**Planning Board Meeting Agenda
Brunswick Town Hall
85 Union Street – Council Chambers
Tuesday, February 10, 2026 @ 6:00 PM**

4. **Case No. 25-059 – MaineHealth Mid Coast Cancer Center Renovation:** The Planning Board will review and act upon a **Site Plan Amendment** application submitted by Pine Tree Engineering on behalf of the property owner, Mid

DRAFT FINDINGS OF FACT SKETCH PLAN MAJOR DEVELOPMENT REVIEW PLANNING BOARD

4 PHARM EAST
A4.01 3/16" = 1'-0"

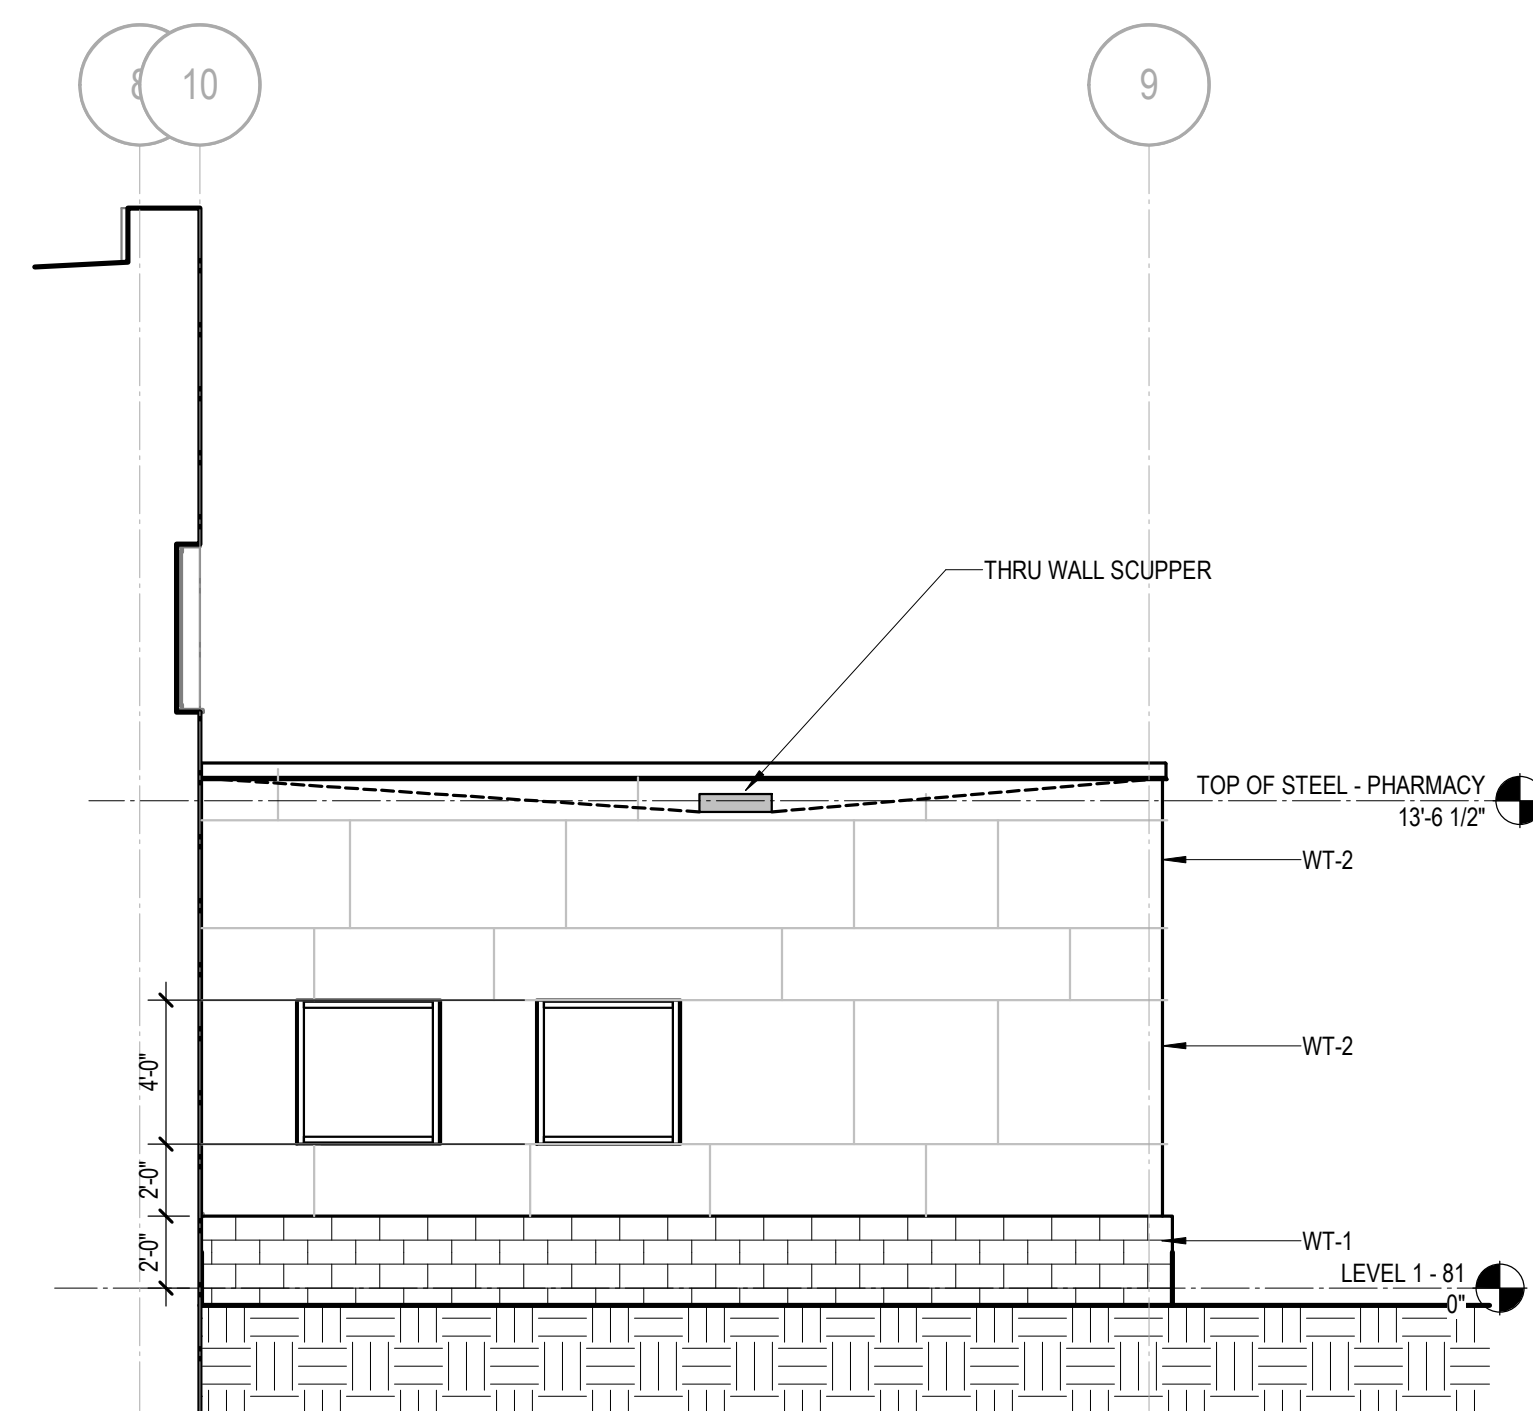
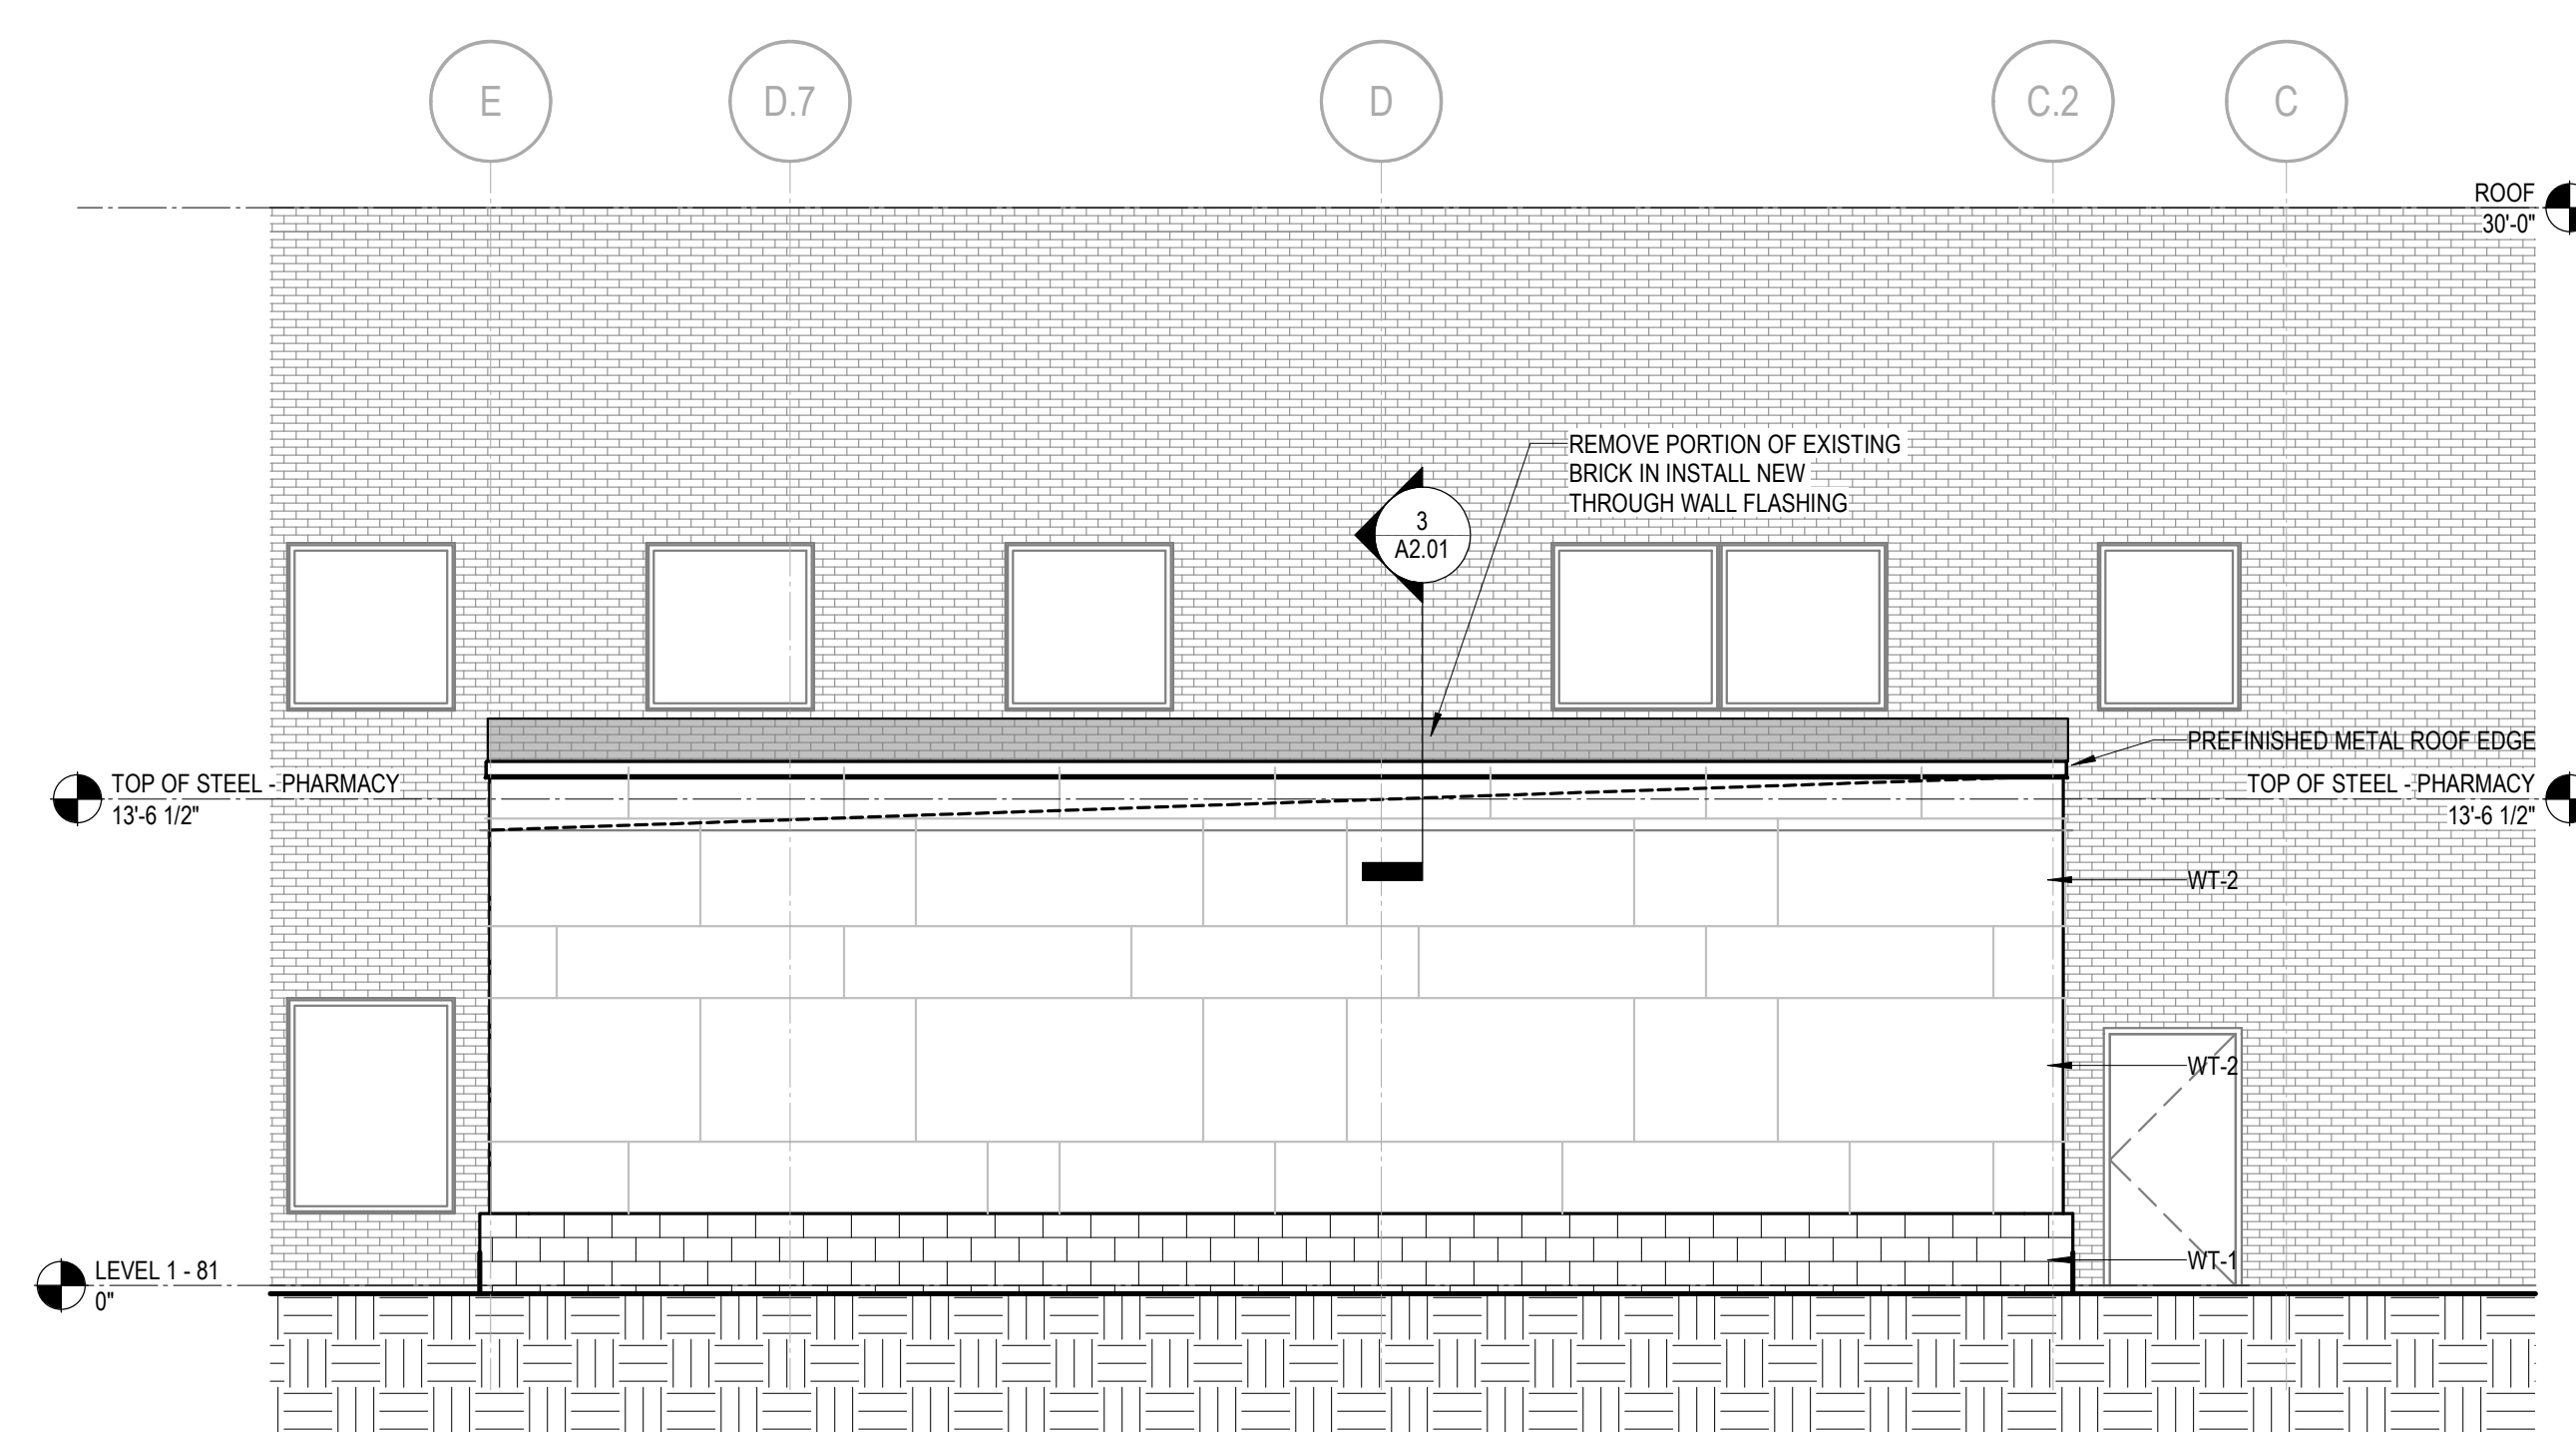
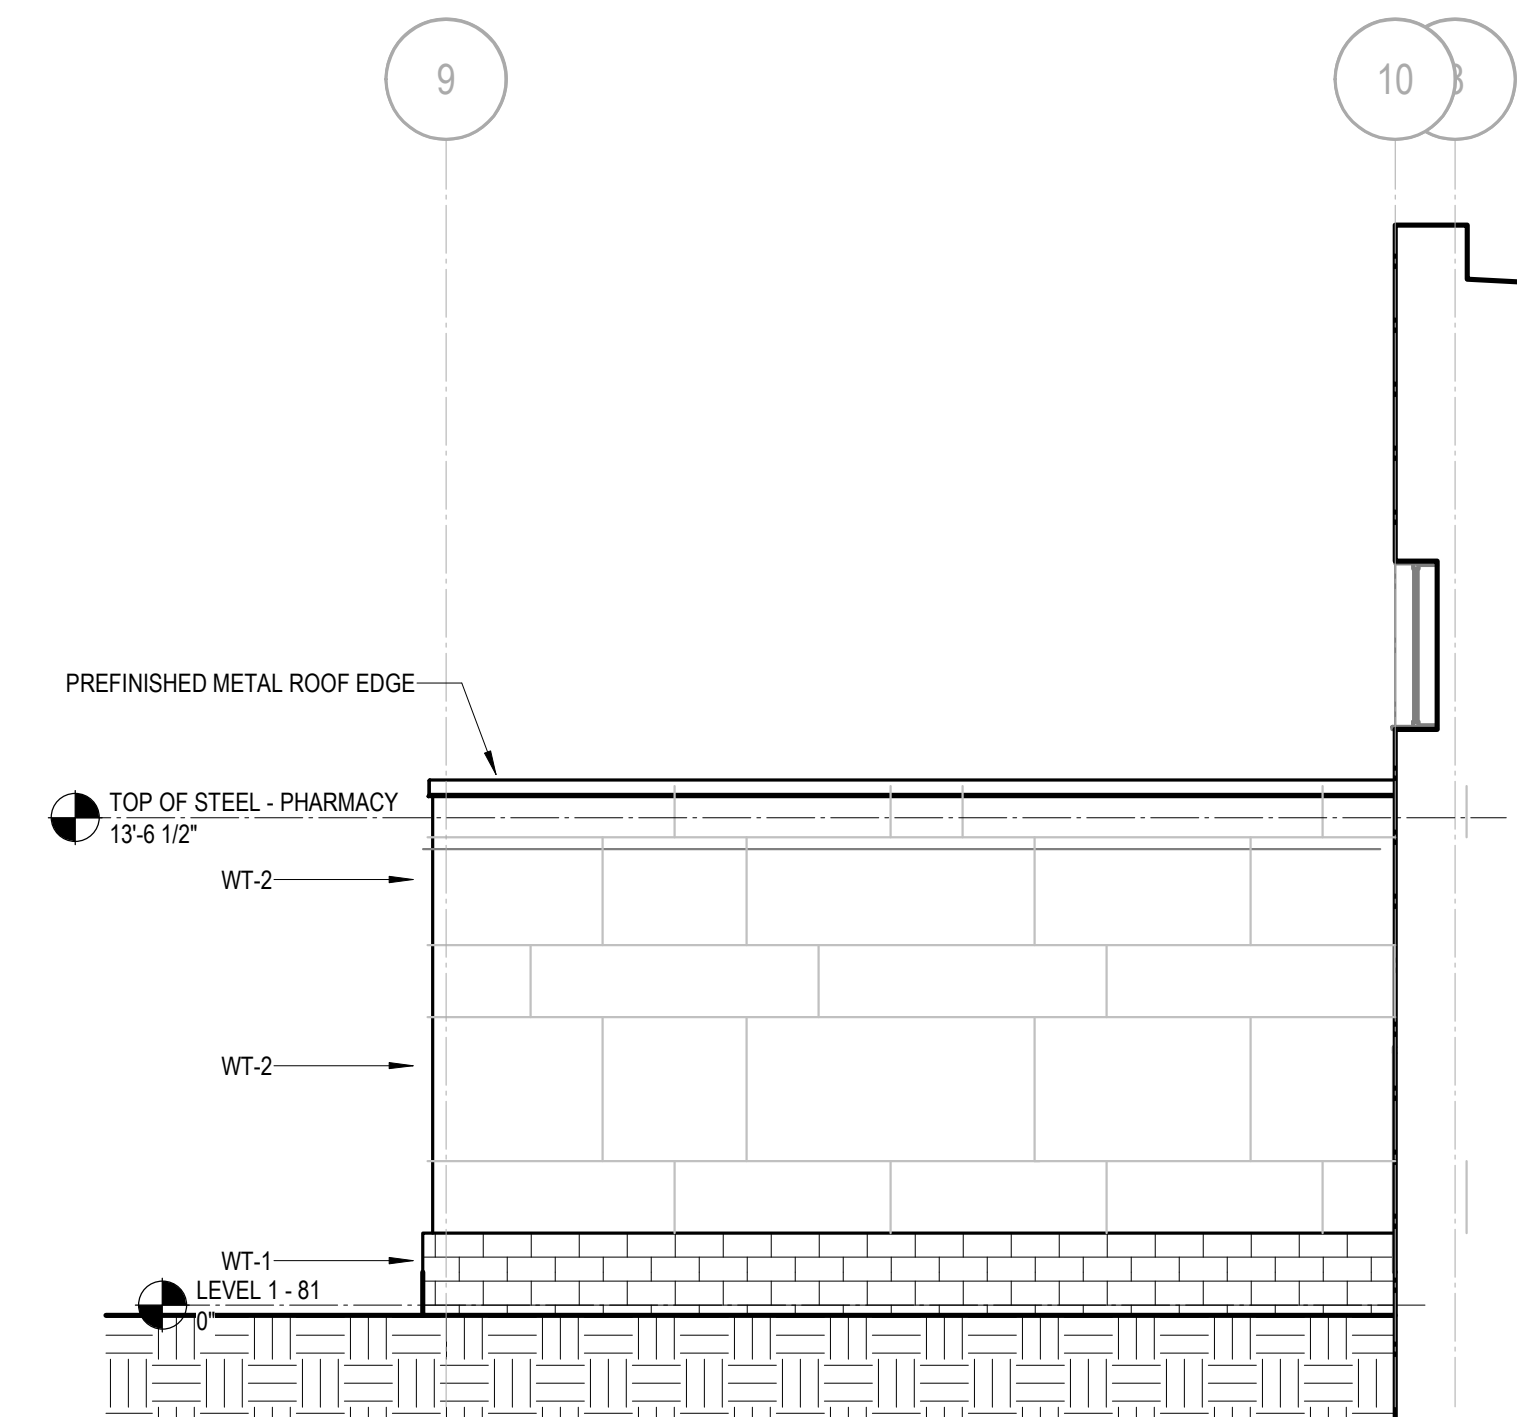
3. Add ornamental grass along parking lot side of pharmacy, near bollards	See Section B-B on AS3.00 Civil Details
Architecture Comments	
4. Review Cooks Corner Design Standards, specifically Section 3.4 Façade Requirements, and within 3.4.j.	See Exhibit 8: Cook's Corner Design Standards Narrative.
Engineering Comments

The two additions to 81 medical center drive are secondary facades according to the definition in Section 3.4 Façade Requirements item C.
